**Steven H. Emerman, Ph.D.**  
Specializing in Groundwater and Mining

March 21, 2021

I am writing to address the following question: What is the implication of the above event for the validity of the AECOM and Seamon-Whiteside stormwater models? Before answering this question, I will first review the relationship between the AECOM and Seamon-Whiteside stormwater models and what was previously known about their validity.

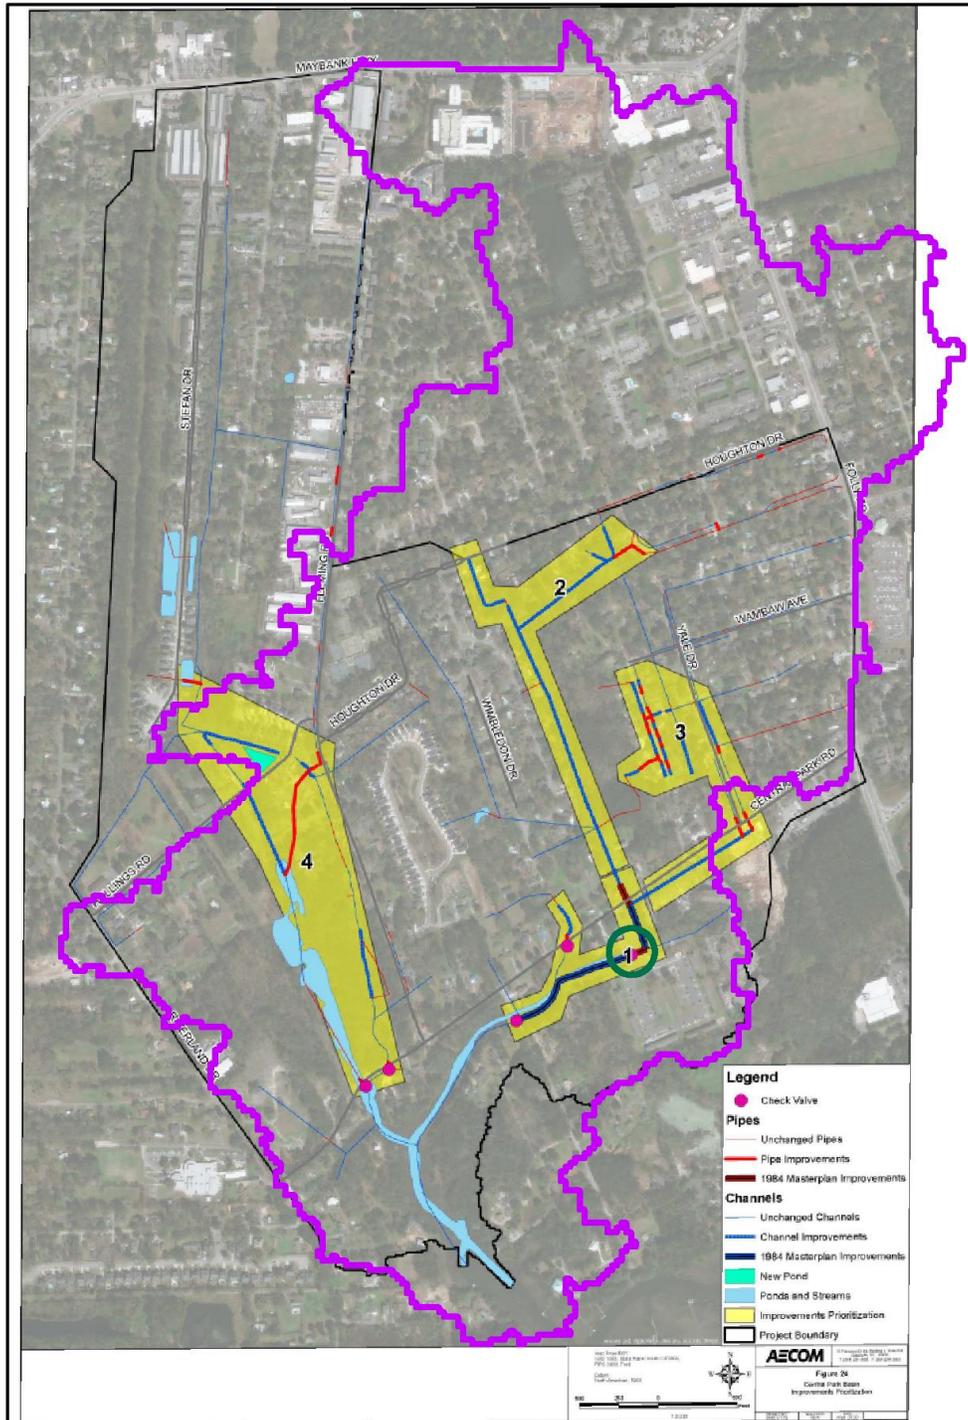
On March 18 Jimmy Mazyck documented the 48” stormwater pipe at EME Apartments flowing completely full (see left-hand side of Fig. 1). The parallel 42” stormwater pipe was not flowing since it had been sealed with rocks for an unknown reason (see right-hand side of Fig. 1). The location of the pipes is the center of the green circle in Fig. 2.

I am now directly addressing the significance of the photographs in Fig. 1. If the unsealing of the 42” pipe could make no contribution to drainage, then the 48” pipe could never flow completely full. If the AECOM model predicts that the unsealing of the 42” pipe could make no contribution to drainage, then the AECOM model has questionable validity.
